APPENDIX H

Requests for Information

Project Name:	Permanent Crossing Plan Round CSP Culverts	Project #	Tote Road Culvert Remediation
RFI #	1	Contract #	
Originator:	Michael Burns	RFI Submitted On:	March 6, 2024
Prepared By:	Michael Burns	Requested Response By:	March 7, 2024
Submitted To:	Greg Johnstone	Company:	Knight Piesold

Date:	March 8, 2024	File No.:	NB102-00181/93-A.01
		Cont. No.:	NB24-00286
To:	Michael Burns, Rudolf Dietrich		
Copy To:	Dale Tulloch, Jim Patterson, Sharon Dyke, BIM Document Control		
From:	Greg Johnstone		
Re:	Permanent Crossing Plan - Round CSP Culverts, Response to Baffinland Request for Information (RFI) No. 1

FIGURE 1

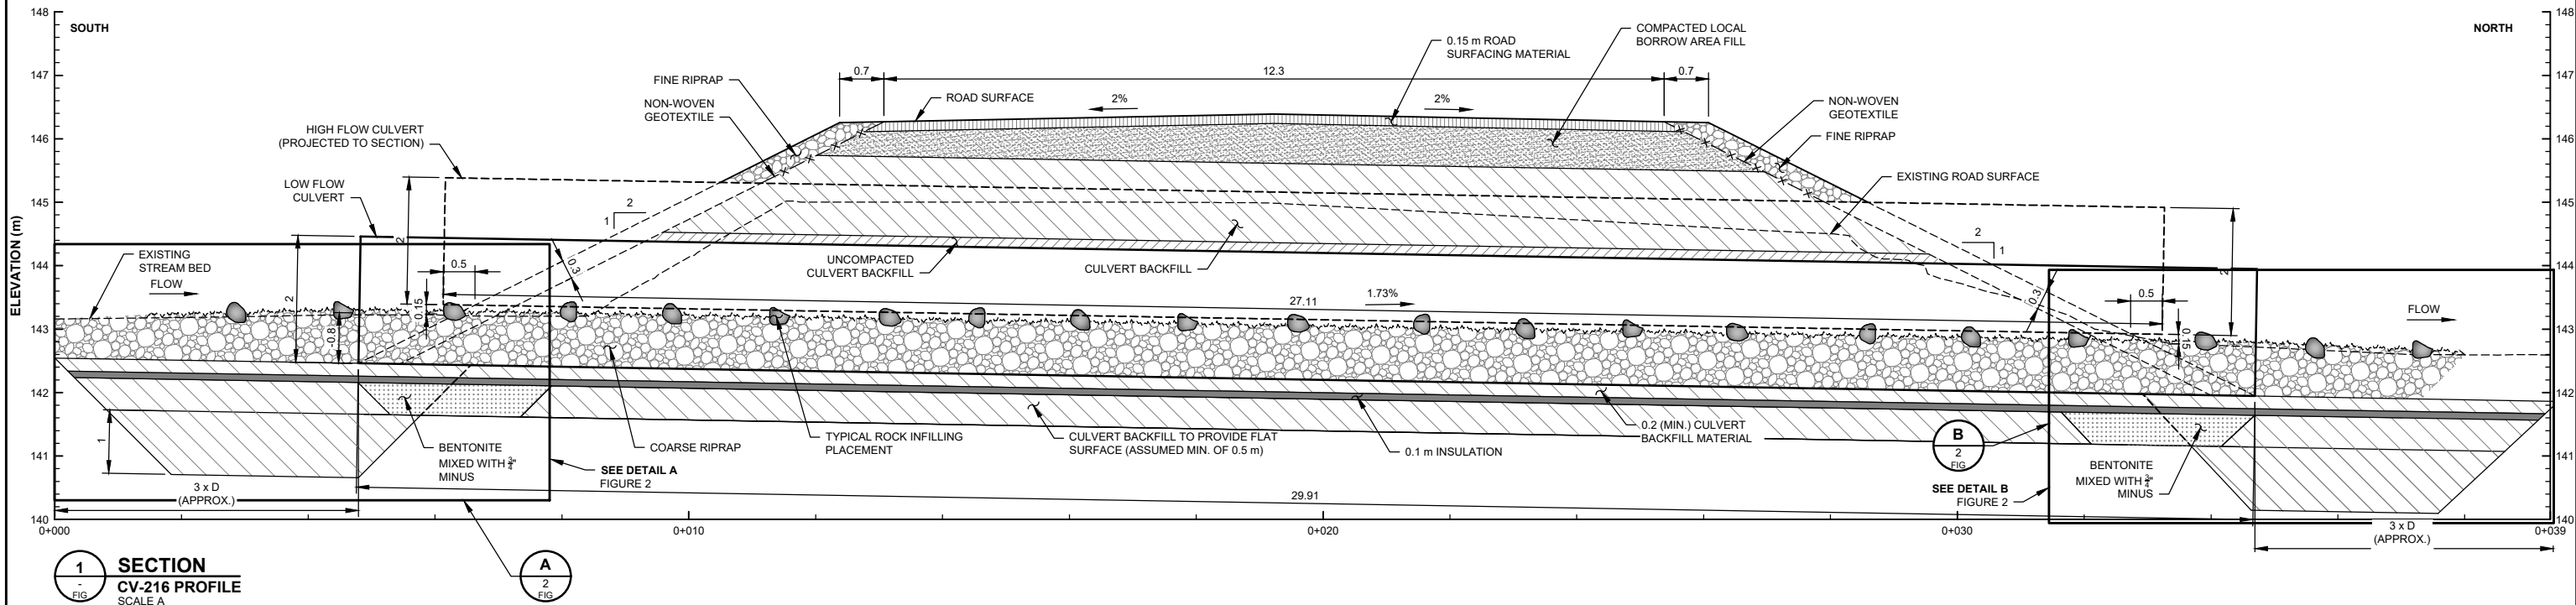
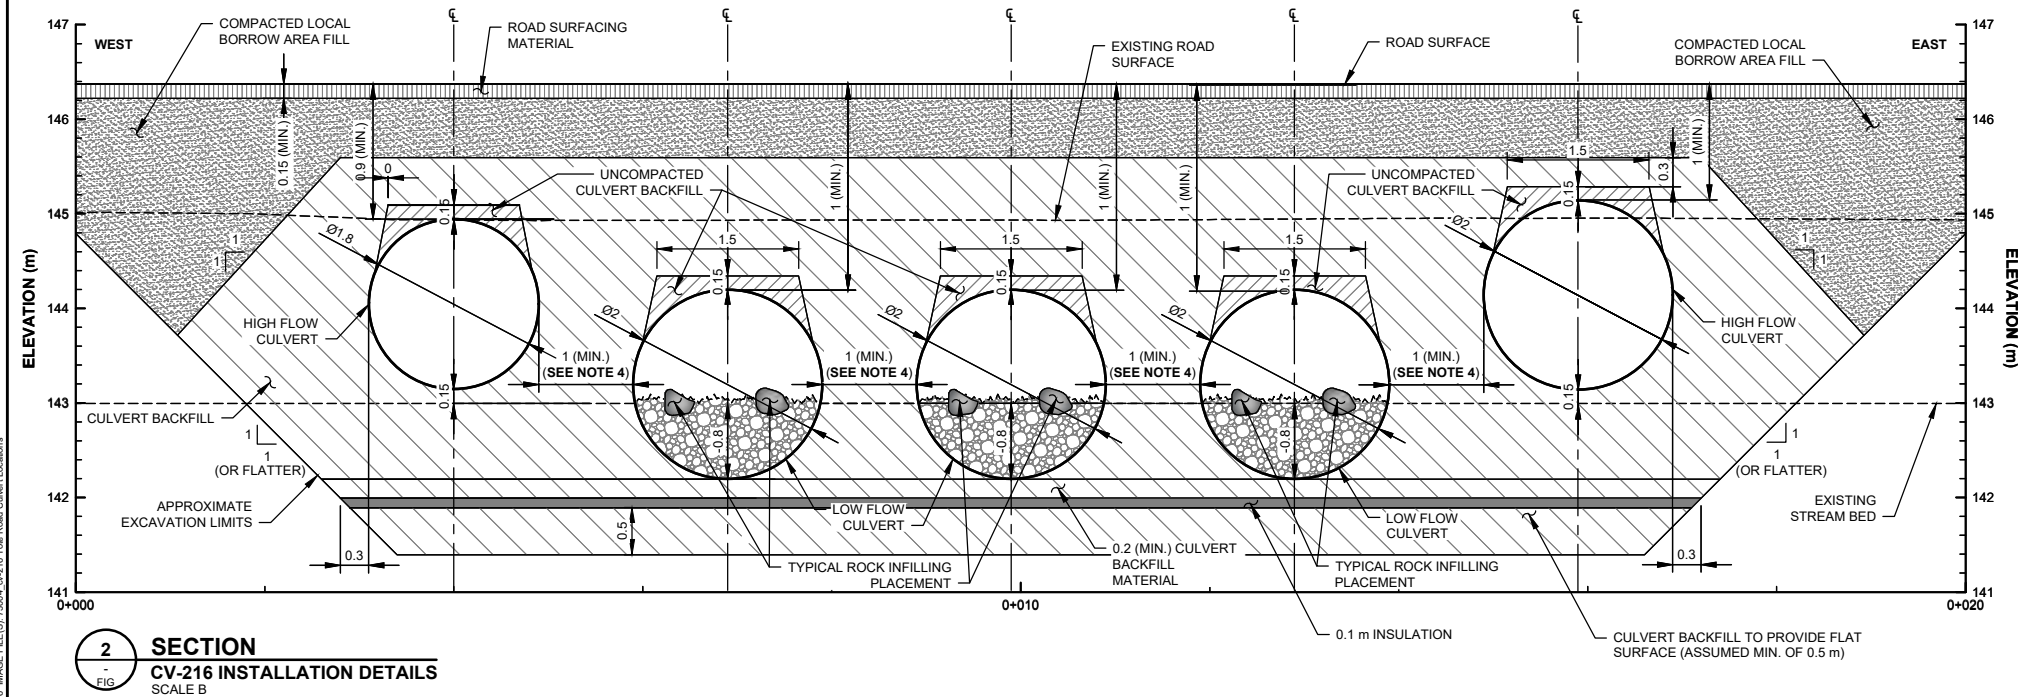
Drilling and blasting at CV-216 during the week of April 8, 2024 exposed massive ice in the northeast portion of the culvert excavation (Photos 1 and 2). Following the discovery of the massive ice on April 12, 2024, Baffinland halted excavation and informed KP. KP reviewed the photos and survey of the massive ice in relation to the design and developed the design change details illustrated on Figure 1.

The CV-216 inlet and outlet areas will be constructed similar to locations CV-102 and CV-106 as shown on Drawing 781 Detail D provided with the original design report (KP, 2024). The proposed design change is shown on the attached Figure 1 and the inlet and outlet apron detail is shown on Figure 2.
